May 15, 2025

PROJECT NAME: MSP 9025-0636-18 PROJECT NUMBER: 2024080058 APPLICATION: MINOR SITE PLAN #31902

C002

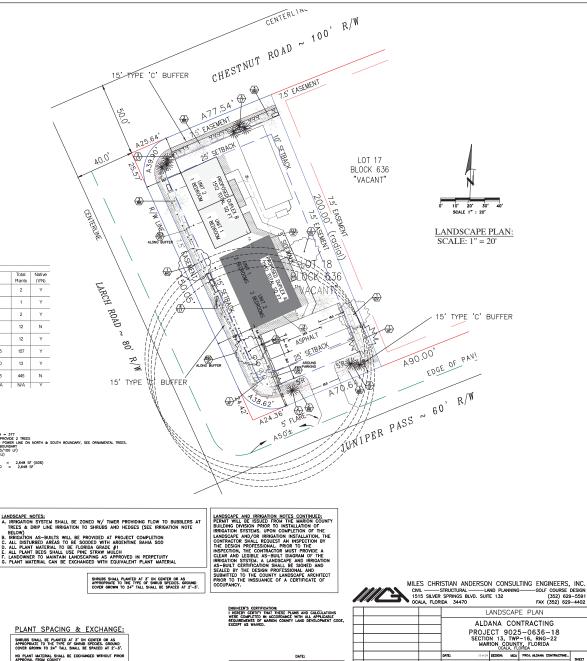
REMARKS: Sheets C001, C002, & C003, on Duplex A, the units need to be numbered from left to right when facing the front of the building. Please swap the unit numbers.

- 13 DEPARTMENT: LSCAPE LANDSCAPE DESIGN AND IRRIGATION REVIEW ITEM: 6.8.6 - Buffers STATUS OF REVIEW: NO REMARKS: 1. Type C buffer along Juniper Pass does not meet requirements - no OHE is present, provide full buffer 2. Oak and Maple may conflict with wells, adjust location 3. Shrubs in buffer along Chestnut are not labeled

- 14 DEPARTMENT: LSCAPE LANDSCAPE DESIGN AND IRRIGATION REVIEW ITEM: 6.8.10 - General planting requirements (specifications) STATUS OF REVIEW: NO REMARKS: Provide Tree installation detail - (if there are no existing trees, tree protection detail is not needed)
